The following information presented is the Uranerz Energy Corporation responses to the open issues for the Safety Evaluation Report for the Nichols Ranch ISR Project.

2.2 – Meteorology

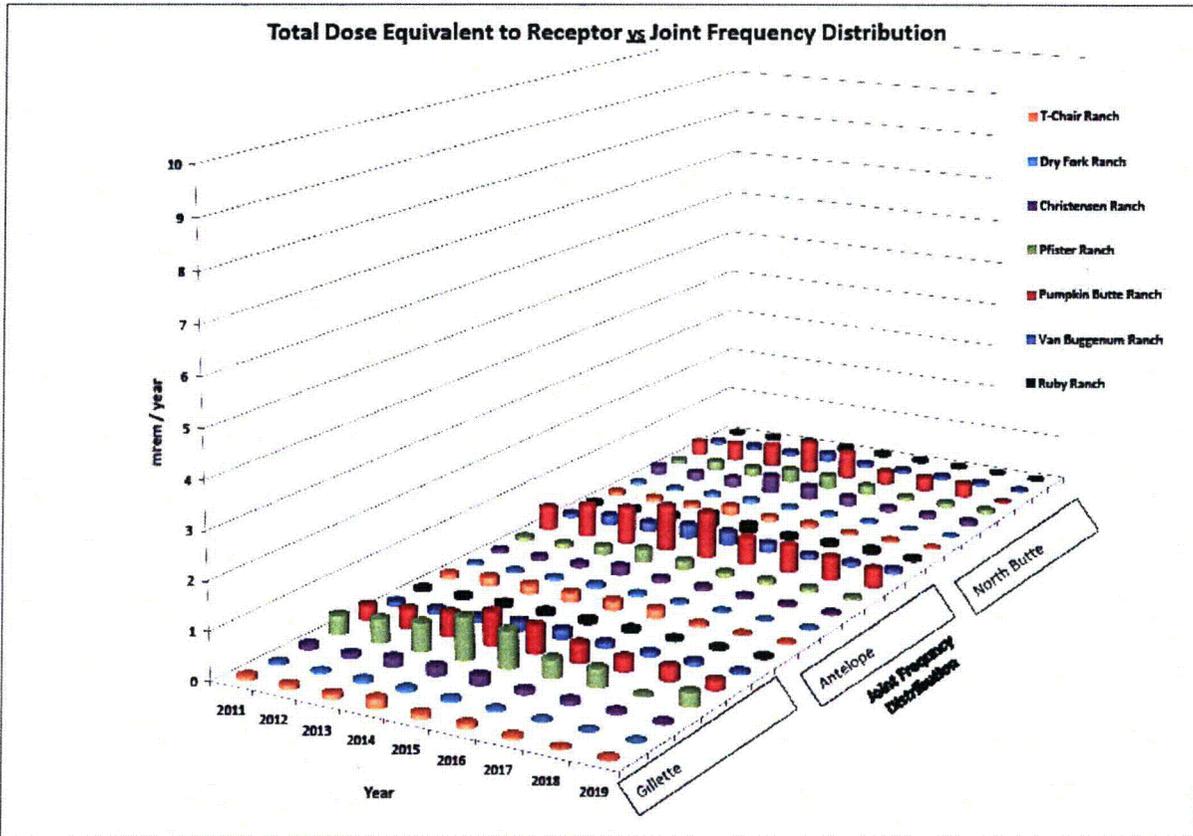
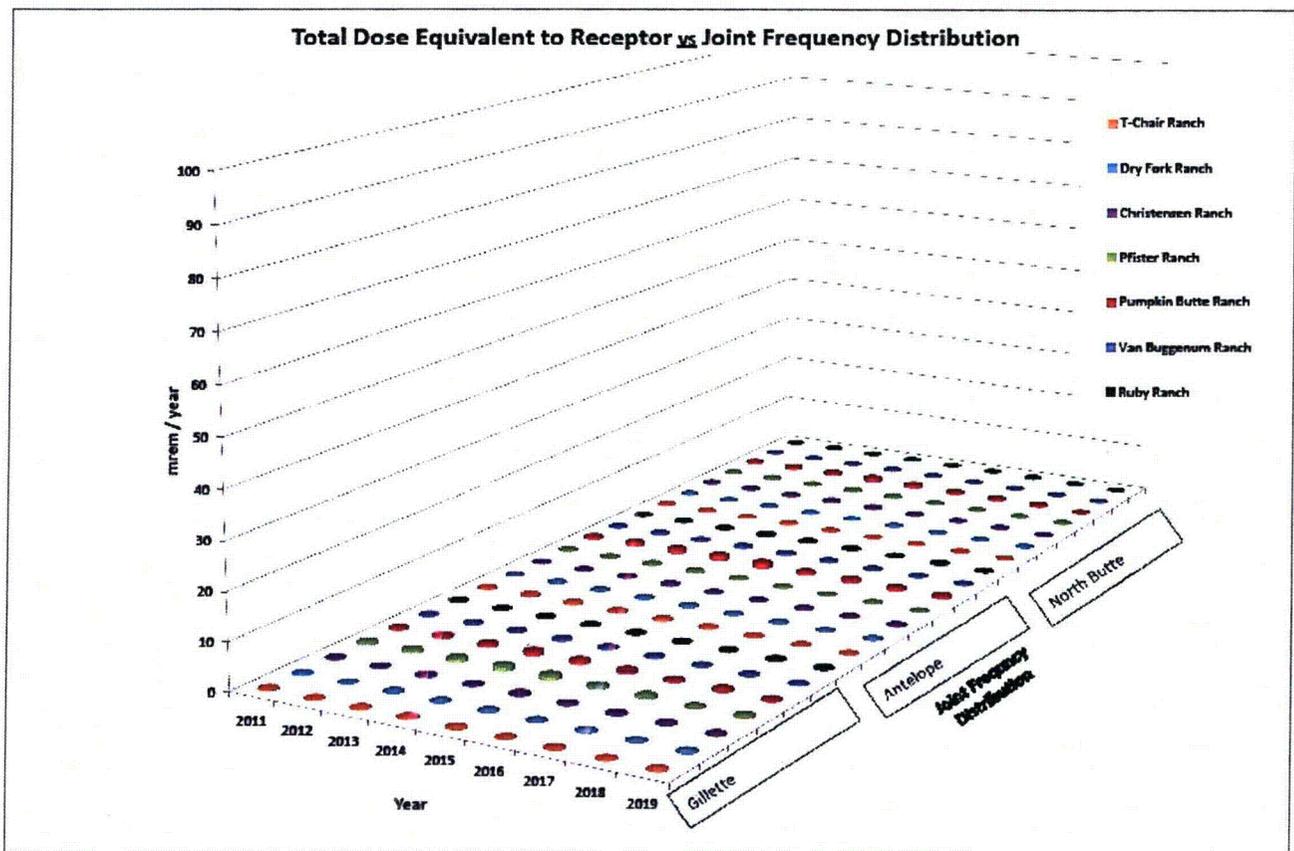
- 2.2.1 Uranerz has not provided sufficient information regarding the atmospheric stability of the site for the staff to evaluate its use of the Antelope station in lieu of site-specific data. A summary of the MILDOS methodology used to determine the atmospheric stability and the results contained in Addendum 7C should have been provided. **This is an open issue.**

Prior to this response, Uranerz had run the MILDOS model using two different atmospheric stability arrays: the first run utilized a long-term data set (1996-2005) from the National Weather Service (NWS) station at Gillette, which was obtained from the National Oceanic and Atmospheric Administration (NOAA); and the second data set was developed from a private meteorological station associated with the Antelope Coal Company. Additional details on the Antelope meteorological station (years of operation, data recovery, etc.) are provided in response item 2.5.1.

A review of the MILDOS results from the two previous submissions (see Chapter 7), shows that the use of the above-noted stability arrays did not cause a significant change in the predicted doses to the public. Because of the climatic similarities between Antelope and the Hank/Nichols Ranch project site, the similar results in the two MILDOS runs came as no surprise. Although this was the case, Uranerz decided to make a third MILDOS run to further demonstrate that the dose projections generated by the MILDOS model are not significantly different when using generally applicable stability data.

As can be seen from the new MILDOS results (attached to these responses) and the two graphs below, predicted dose values are in tight agreement with the previous estimates. All three runs demonstrate that any of the three sets of stability data are appropriate for use for the Nichols Ranch ISR project with all predicted does values being very small and very much under regulatory dose values. Therefore the Antelope data is appropriate for use.
